Clark & Enersen Project No.: 097-045-19
LPS Bid #: 11090

ADDENDUM NO. 1

LPS Southeast Activities Complex

Item 1-2: SEAC - Sheet A0.02 – Exterior Assemblies

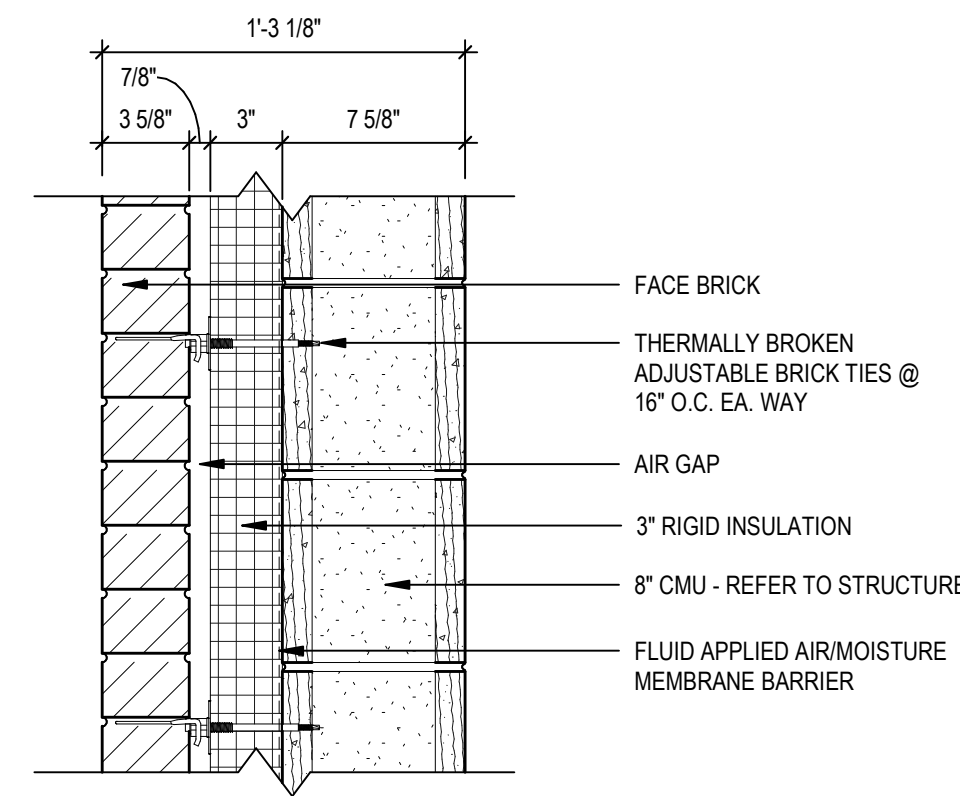
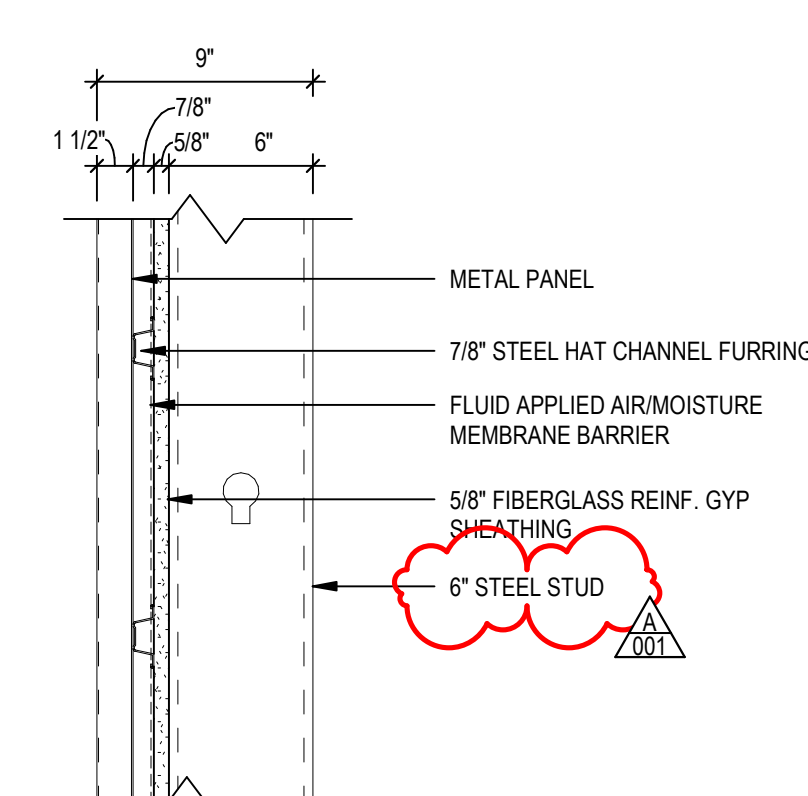
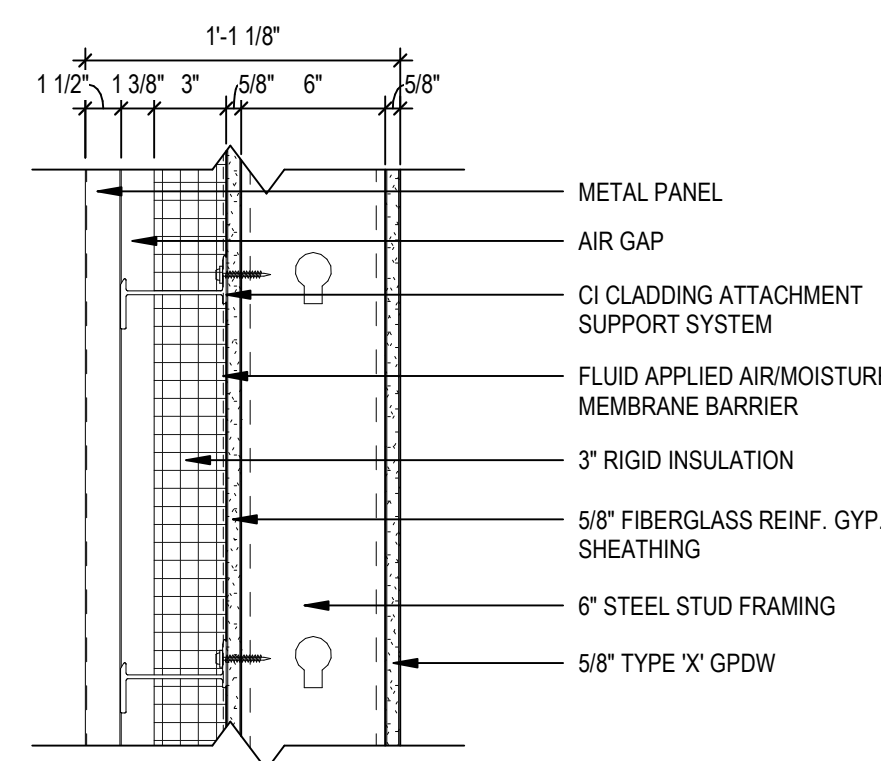
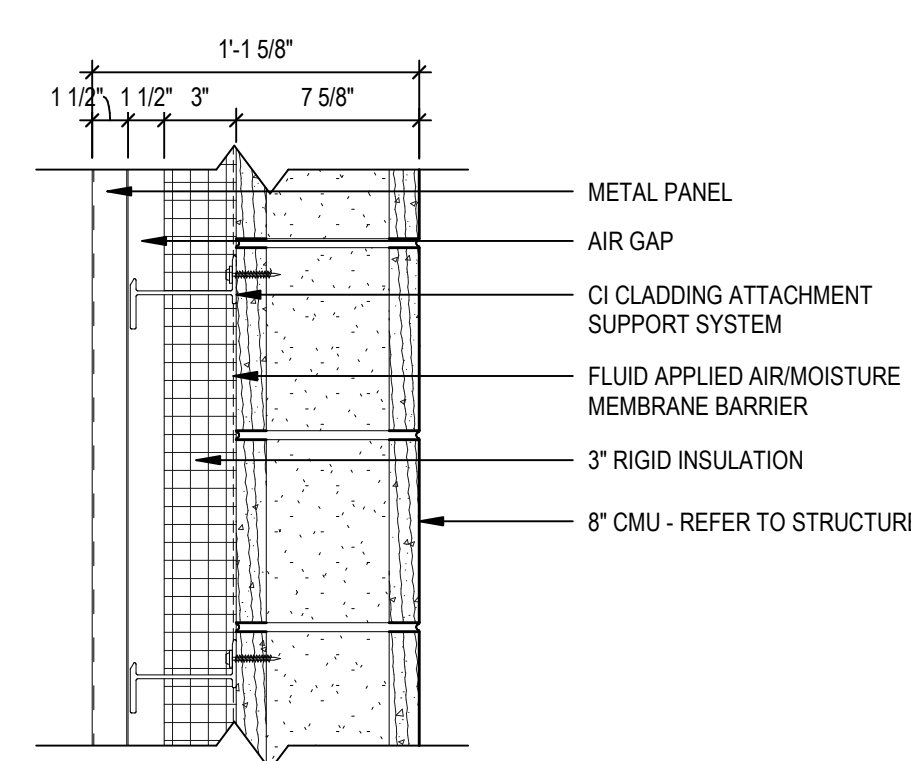
Refer to attached revised sheet. Notes revised in exterior assembly details.

Electrical Site
 Utilities Plan

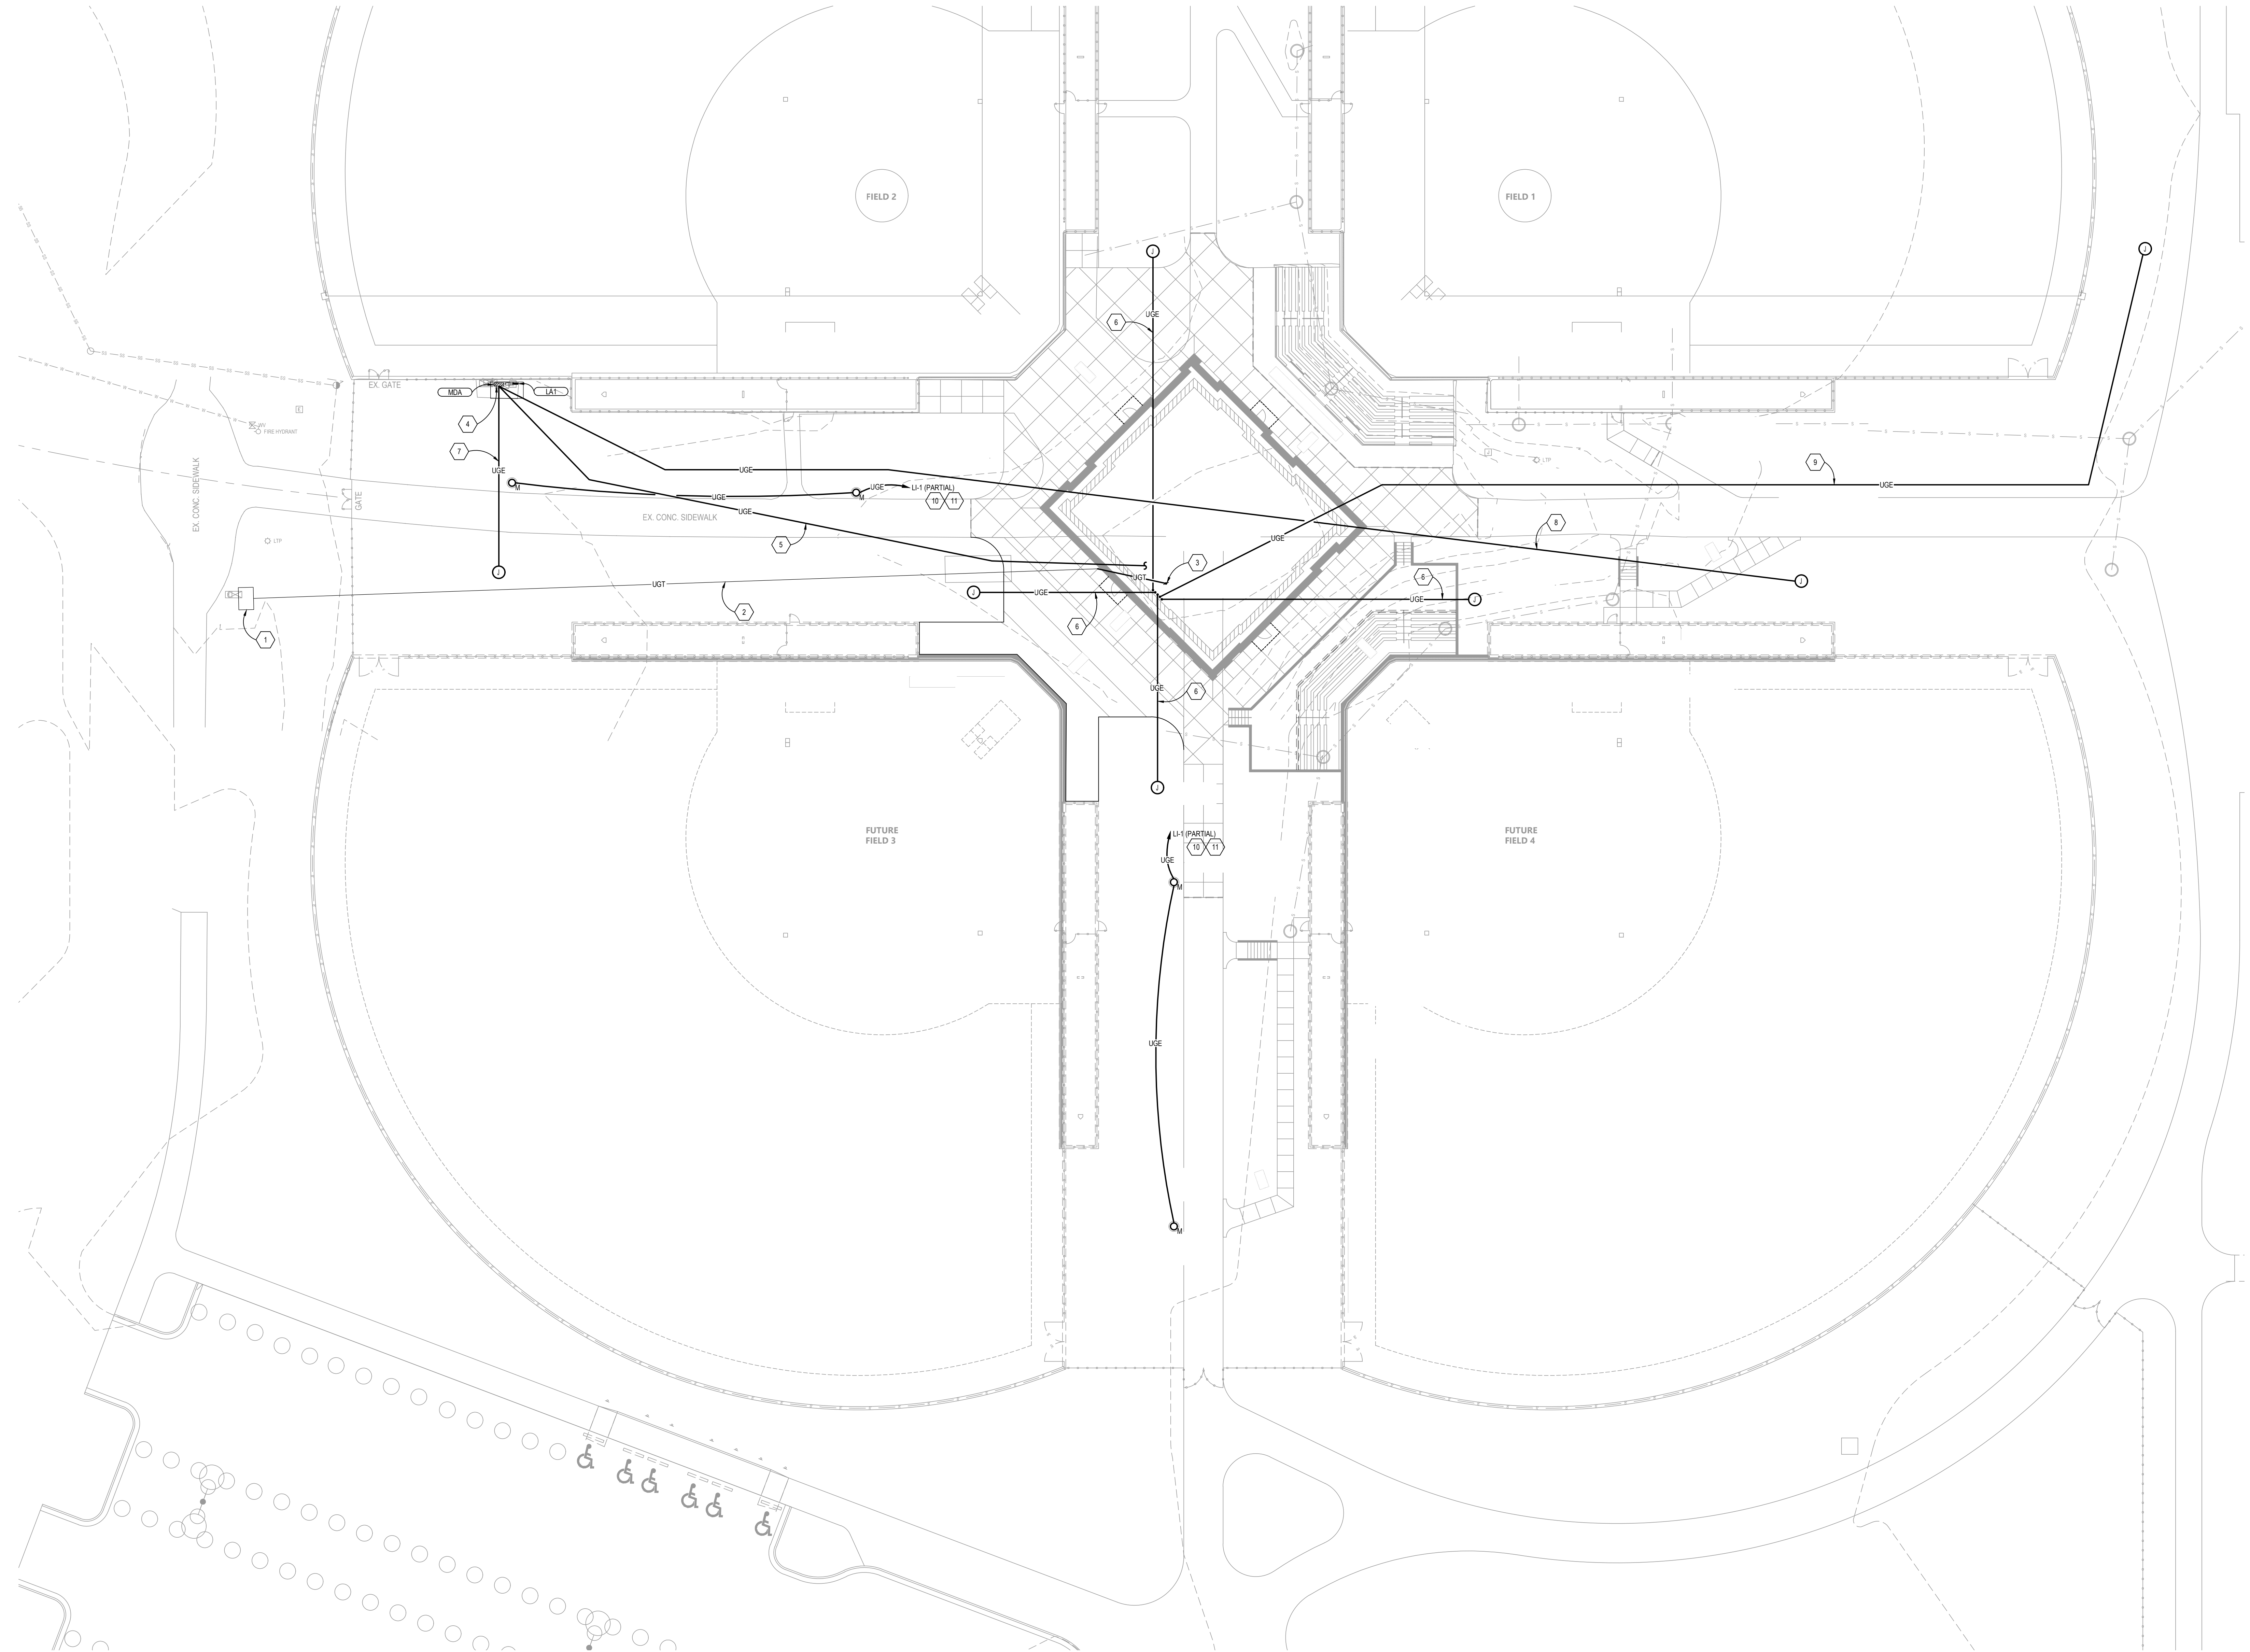
This sheet has been revised and reissued in its entirety as part of this Addendum to show new fiber back to the school, in lieu of splicing.

OVERALL ELECTRICAL SITE UTILITIES PLAN

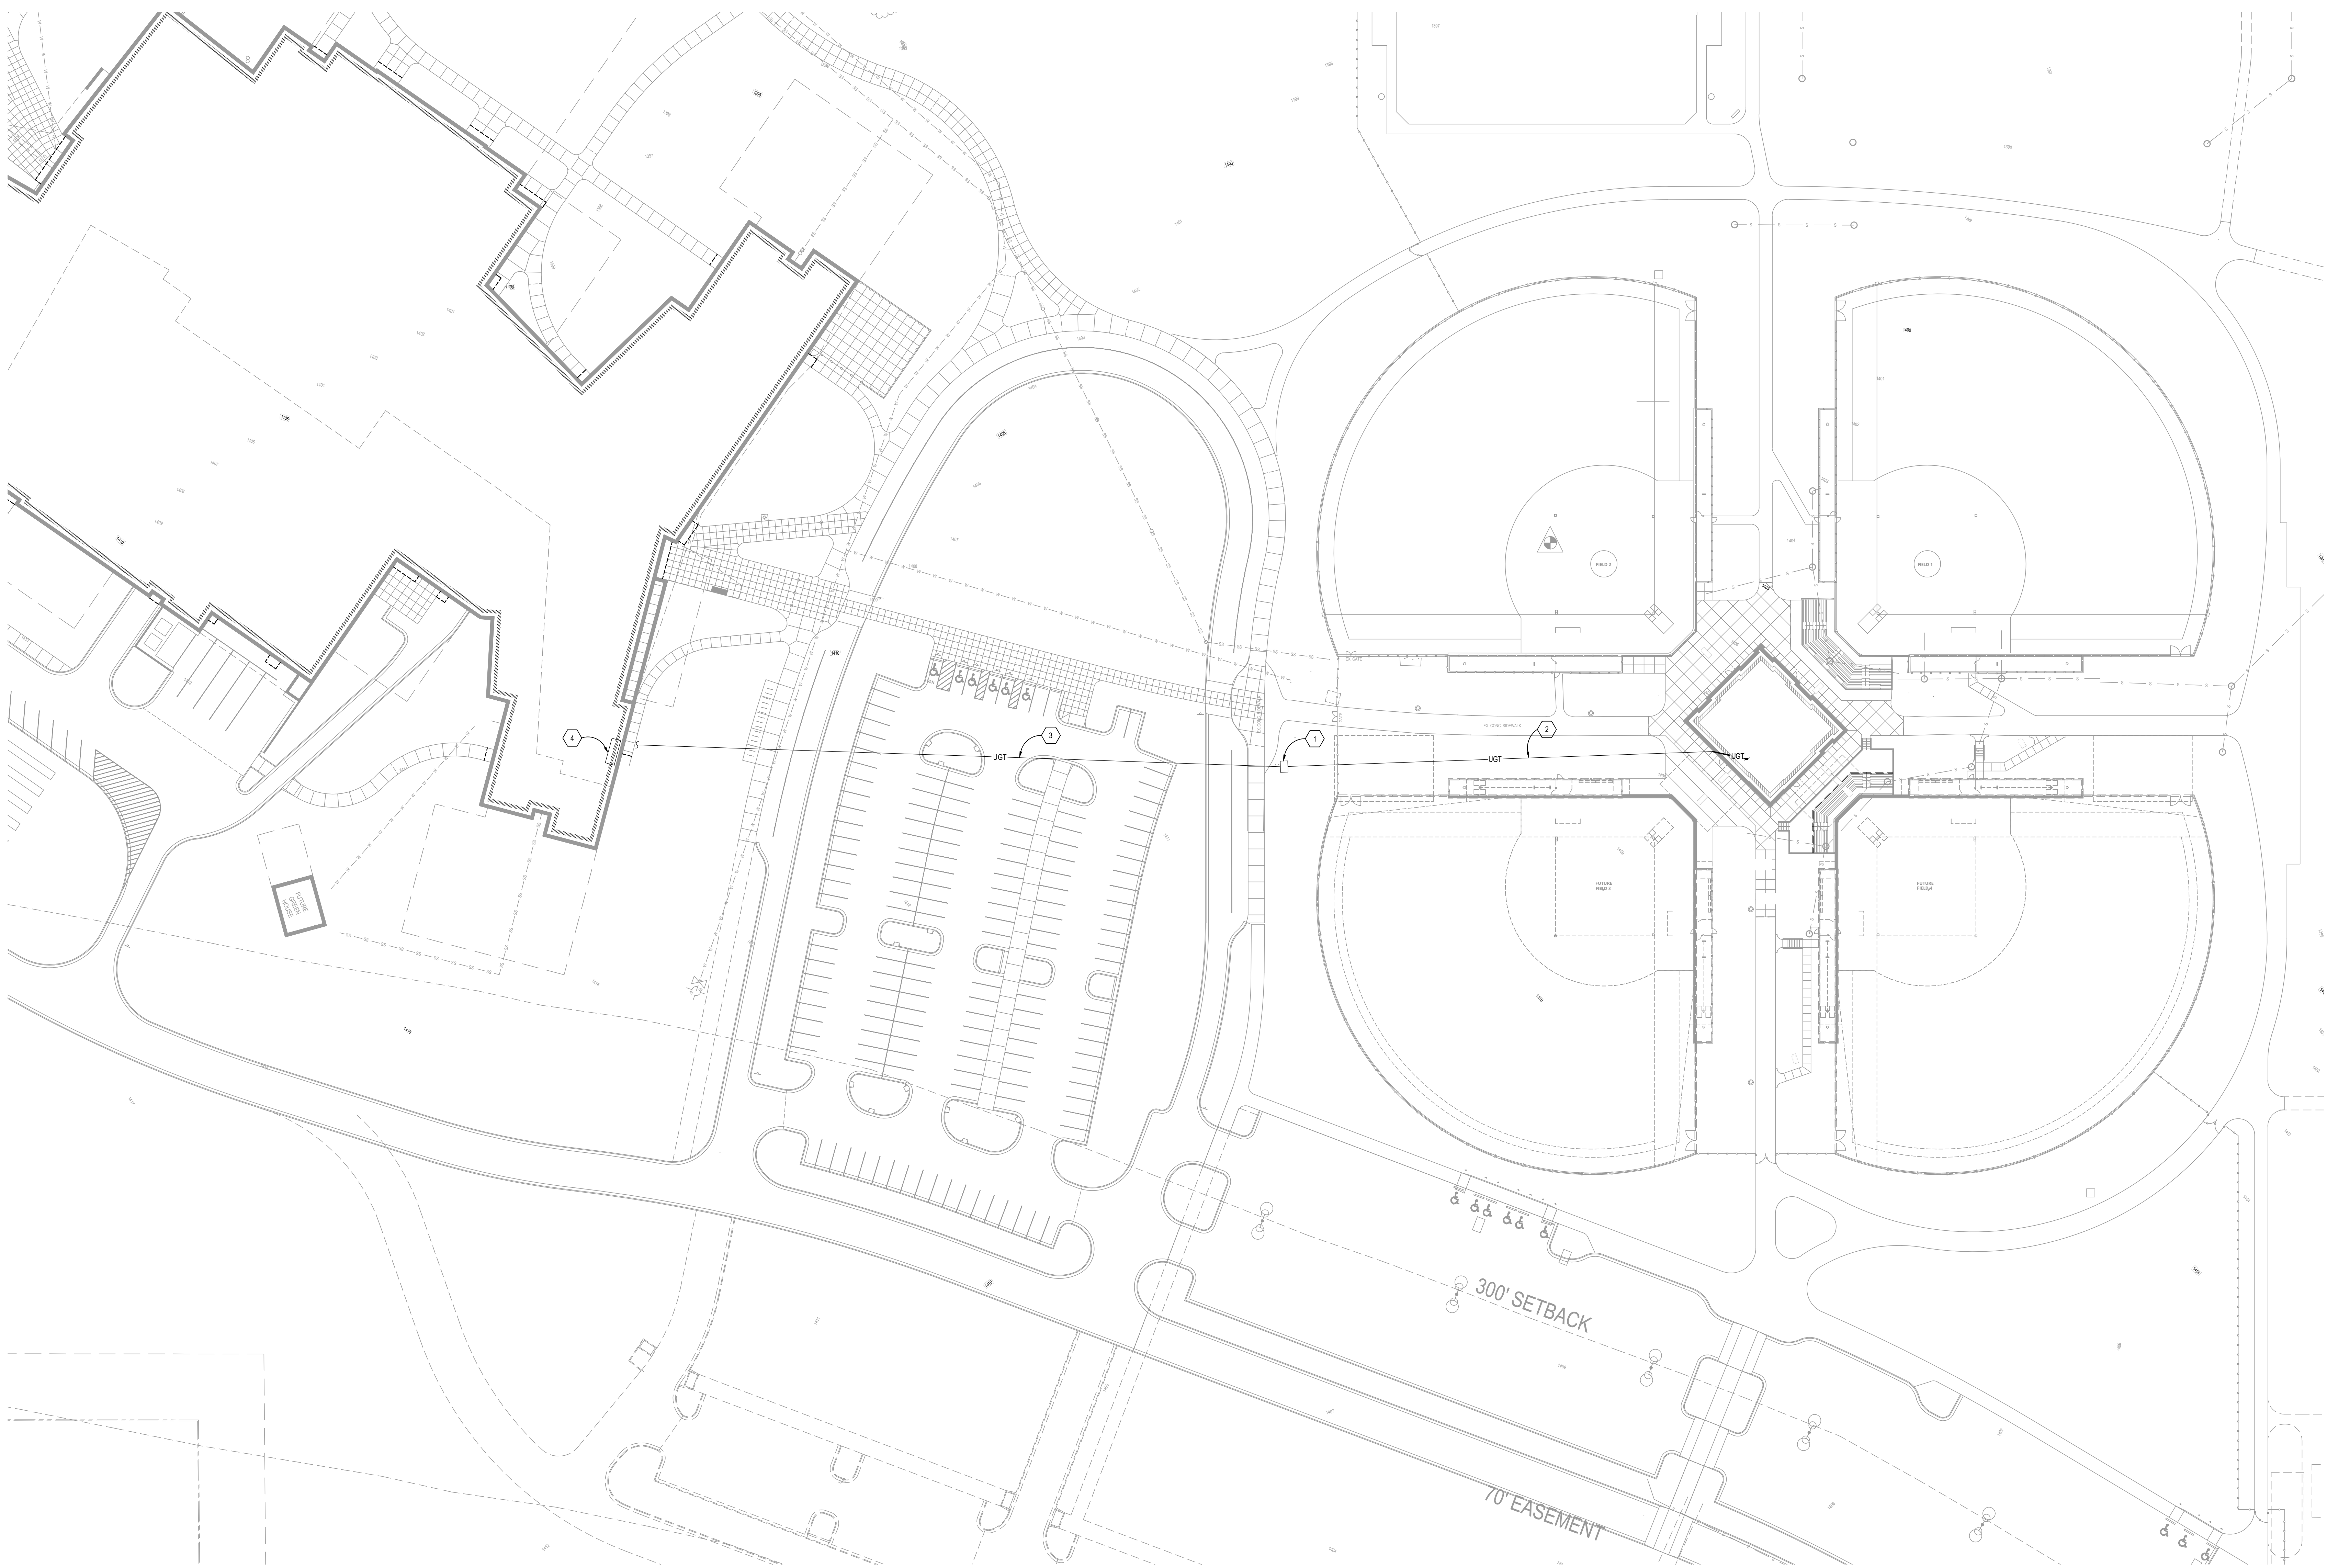
This sheet has been added in its entirety as part of this Addendum to show new fiber back to the school, in lieu of splicing.
